UPPER BRUSHY CREEK WCID  
MODIFICATIONS TO FLOOD PREVENTION DAMS NO. 3 AND 4  
BKW08426

ADDENDUM NO. 1  
September 25, 2009

- A. Reference: Detail 2

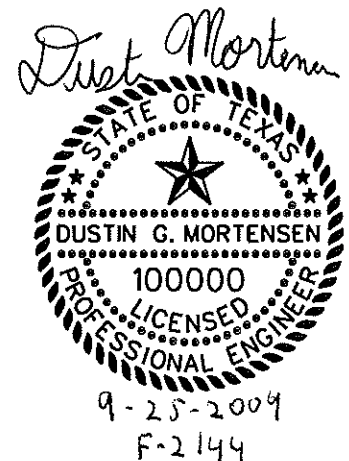
Change the reinforcement to #4 bars.  
Change the wall thickness to 8" and the upstream toe to 9".
